DESIGN EXCEPTION REQUEST FORM

PROJECT DATA	
Current Project Phase	Context/Scoping ☐ Footprint Established ☐ Plan-in-Hand ☐ PS&E ☐ (Base Technical Concept for Design-Build RFP)
County/ City	Lauderdale
PIN	136185.12
Federal Project No.	N/A
State Project No.	R4SVAR-S1-049 (DB 2506)
Project Limits	SR 87 Bridge over Branch, L.M. 19.11
Local Program Project	Yes ☐ No ☒ If yes, then
State Let	Yes ☒ No ☐
Local Let	Yes ☐ No ☒
Project Type	New Alignment ☐ Reconstruction ☐ Resurfacing ☐ Road Diet/Road Reconfiguration ☐ (Note: Road Diet Evaluation form may be required) Maintenance ☐ Road Safety Audit ☐ Bridge Repair ☐ Bridge Rehabilitation ☒ Signalization ☐ Other ☐
US Route/NHS	Yes ☐ No ☒
State Route	Yes ☒ No ☐
Appalachian Development Highway System	Yes ☐ No ☒
FHWA RBI Project	Yes ☐ No ☒
Project Scope (Briefly describe the objective of project)	Replacement of existing Timber Bridge over Branch
Project Commitments	N/A

STATE ROUTE 87
BRIDGE OVER BRANCH, L.M. 19.11
LAUDERDALE COUNTY

FIGURE 1d
S.R. 87
L.M. 19.11

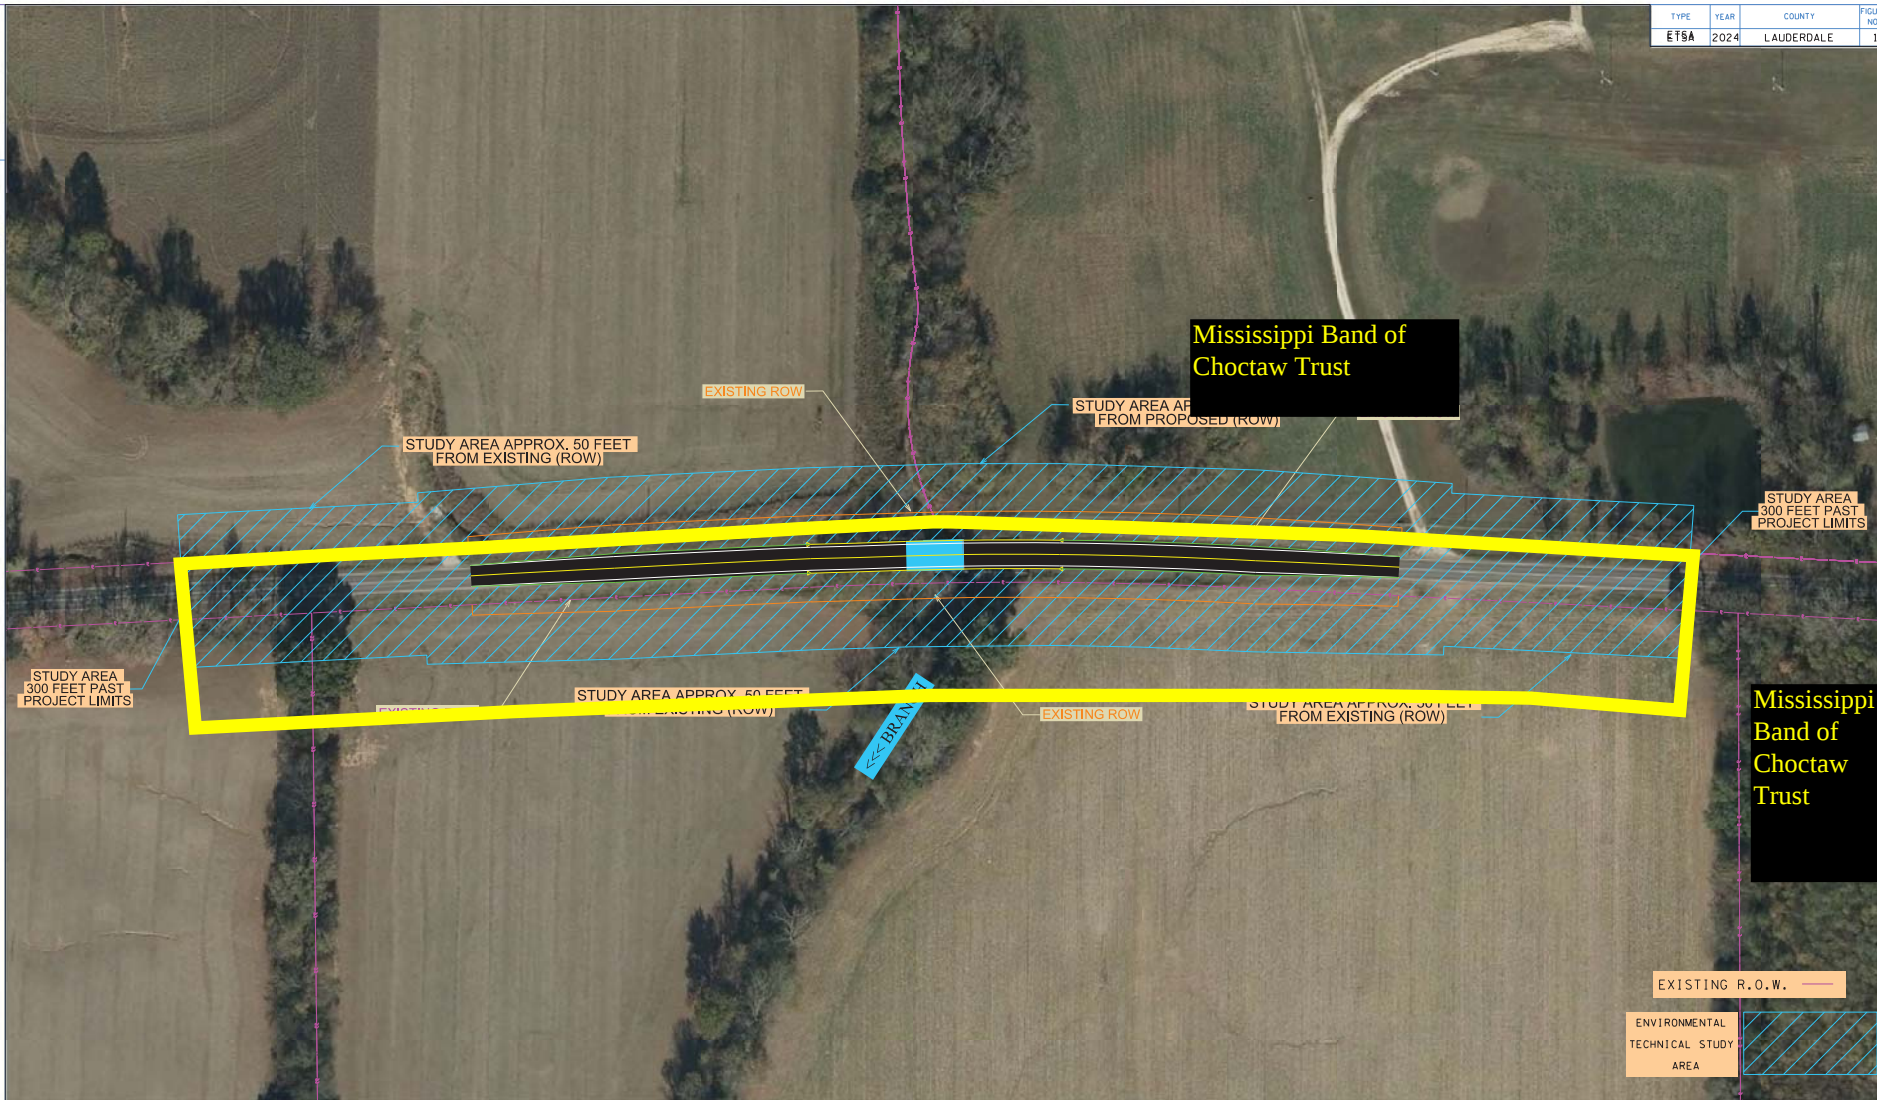
Any word on the ETSA shift for Bridge #50 on SR-87? We need to update our consultant if this shift is possible, if not to possible we would need to start the ARPA permit process.

I also need to discuss the need for an ETSA revision at Bridge #50 on SR-087 in Lauderdale Co. One of the adjacent properties is owned by the Choctaw Nation and held in trust by US Department of Interior, Bureau of Indian Affairs. To do Archaeology work on this site would require a Federal ARPA permit. The person doing those permits has recently retired and the workload has been transferred to a new person. We have not worked with the Bureau of Indian Affairs on this permit type before, but with other federal agencies (US Army Corps, Park Service, Forest Service, etc.) the process has take 10 months to 2 years. It does appear that we have an opportunity to shift the ETSA off the property and keep the project in the bundle, we just need to discuss this option. I have attached a proposed shift that would avoid the property in question. Let me know your thoughts.

Gabe stated the ETSA limits in yellow that you provided will work. The only thing being that the Team will need to look into the tie in points more on either end.

The team will make a note to make sure we stay within the ROW on the north side and out of the Choctaw property and make sure to address this in the RFP.
